SIL 16-WT-26

SUBJECT: Torque Converter Pumps Without Charging Pump Tangs

MODELS AFFECTED: 3000 Series™ and 4000 Series™

Figure 3. Torque Converter Pump without Tangs in PTO Application (Acceptable)

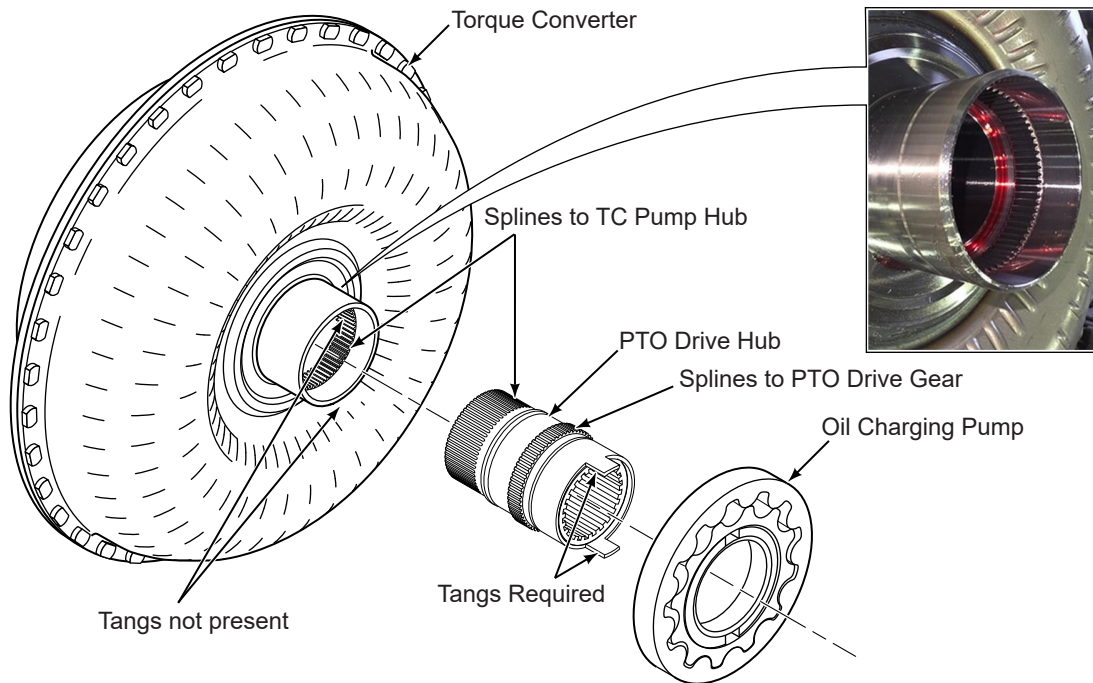
Some 3000 and 4000 Series production builds in June 2025 omitted the torque converter pump hub tangs and were assembled into PTO drive gear-equipped transmissions. This limited production of combined parts was intentional and will not affect the performance of the transmission.

Deviated parts include the 400 Series torque converter pumps (P/N 29514787, 29514790, and 29514791 without tangs) and the 500 Series torque converter pumps (P/N 29514729 without tangs) were accepted for use in 3000 Series and 4000 Series PTO-equipped transmissions, respectively; these acceptable configurations are illustrated in [Figure 3](#).

Part numbers for torque converter assemblies and torque converter pumps without tangs did not change. Torque converter assemblies and torque converter pumps without oil pump driving tangs are compatible with PTO applications since the PTO Drive Hub contains the oil charging pump drive tangs.

Figure 4. Torque Converter Pump without Tangs in non-PTO Application (Unacceptable)

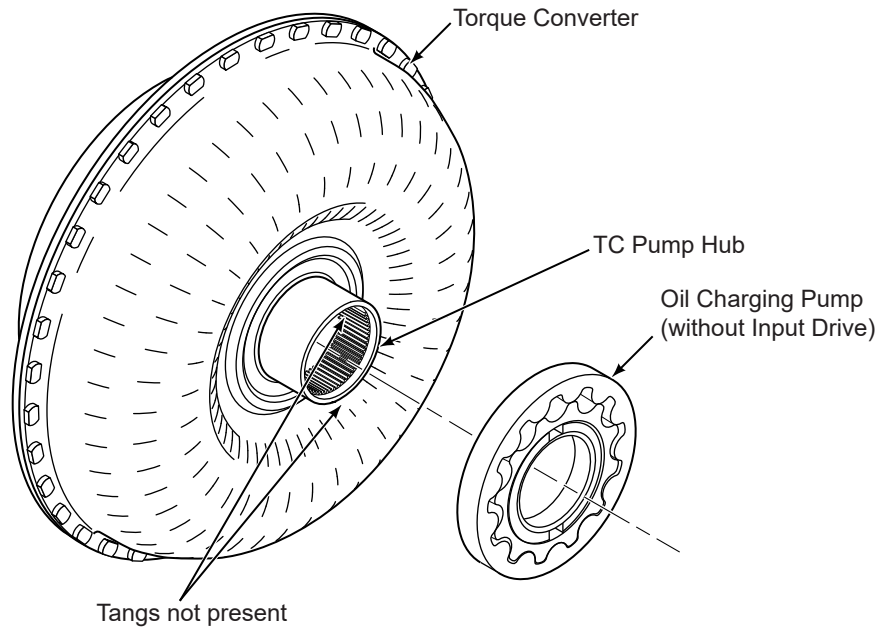
WARNING: Using one of the subject torque converters that does not contain oil pump hub tangs in a non-PTO drive gear application will result in no oil charging pump rotation, and thus no pressurized fluid throughout the transmission system (see [Figure 4](#)).
